Access Compliance Report

Public Rights-of-Way

Intersection ID: 44210	Main Street: MOCKERNUT_DR	Cross Street: PINACEAL_CT	Location: SE
ADA ID: D607C9B9260B	Ramp Type: PerpDiag	Initial Pass/Fail: Fail	Overall Compliance: No
		Severity Score: 12.5

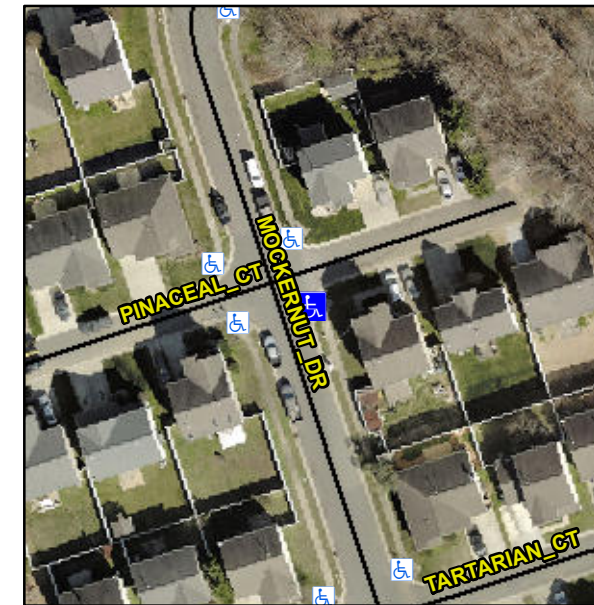
Not Found, R304.5.3

Compliance	Description	Data	Compliance	Description	Data
N/A	Ramp Length (in)	50.5	Yes	Ramp Slope (%)	6.0
Yes	Ramp Width (in)	48.0	No	Ramp XSlope (%)	6.6
N/A	Flare Type LT	N/A	N/A	Flare Type RT	N/A
N/A	Flare Slope LT (%)	N/A	N/A	Flare Slope RT (%)	N/A
N/A	Flare Traversable LT?	N/A	N/A	Flare Traversable RT?	N/A
N/A	Landing Length (in)	N/A	N/A	DWS Provided?	N/A
N/A	Landing Width (in)	N/A	N/A	DWS Contrast?	N/A
N/A	Landing Slope (%)	N/A	N/A	DWS Length (in)	N/A
N/A	Landing X Slope (%)	N/A	N/A	DWS Full Width?	N/A
N/A	Landing Curb? (Y/N)	N/A	N/A	DWS Offset (in)	N/A
N/A	Shared Landing?	N/A			
N/A	Gutter Ponding?	N/A	N/A	Gutter Slope (%)	N/A
N/A	Gutter Lip Ht (in)	N/A	N/A	Gutter X Slope (%)	N/A
N/A	Painted X Walk1?	No	N/A	Painted X Walk2?	No
	X Walk 1 Direction	To N		X Walk 2 Direction	To W
N/A	X Walk 1 Width (in)	N/A	N/A	X Walk 2 Width (in)	N/A
	X Walk 1 Slope (%)	0.5		X Walk 2 Slope (%)	3.8
	X Walk 1 X Slope (%)	3.4		X Walk 2 X Slope (%)	2.1

Remove & Replace Curb Ramp With Two New Directional Ramps or Equivalent.
